ILLINOIS POWER COMPANY

CLINTON POWER STATION, P.O. BOX 678, CLINTON, ILLINOIS 61727

Subject: Clinton Power Station Unit 1  
SER Issues - Pool Dynamics  
Outstanding #9/Confirmatory #13

Figure 480.27-2.3

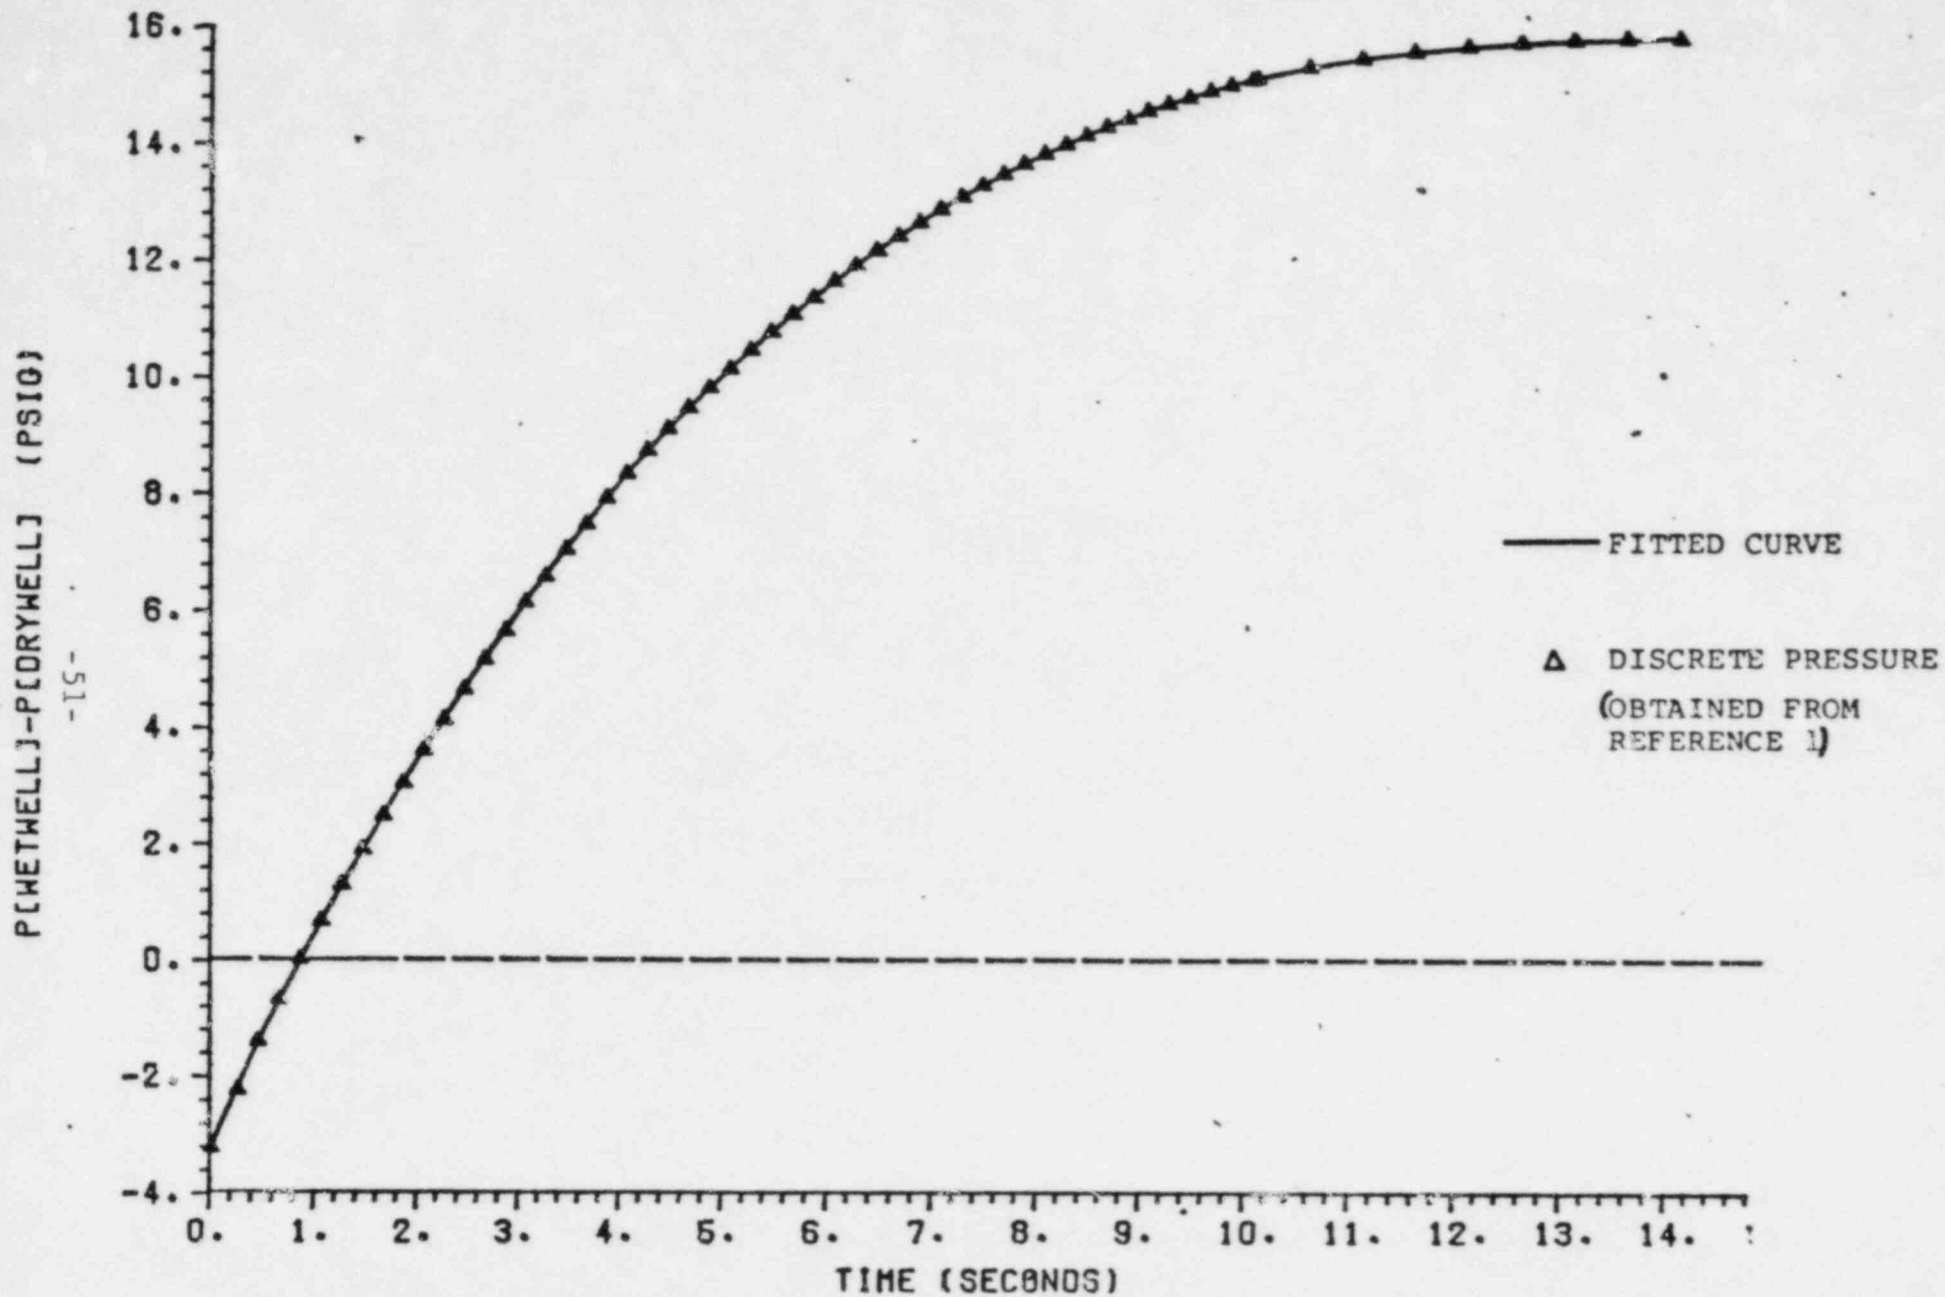
- 2) Provide and justify the load definitions used for structures and equipment that are beyond the scope of the generic load envelope contained in GESSAR-II (e.g., pipes within 0.25 feet of the top of the weir wall, submerged structures in the path of the horizontal vent water jets, and structures in the bulk pool region less than 4 feet long and/or closer than 6 feet from the initial pool surface).

Figure 480.27-2-3 is a plot of the wetwell to drywell pressure difference time history used in this calculation. This time history is for the case with three of four vacuum breakers operating. Both the fitted curve and the points used in determining this curve are plotted. The fitted curve has a standard deviation of approximately 0.026 from the data points.
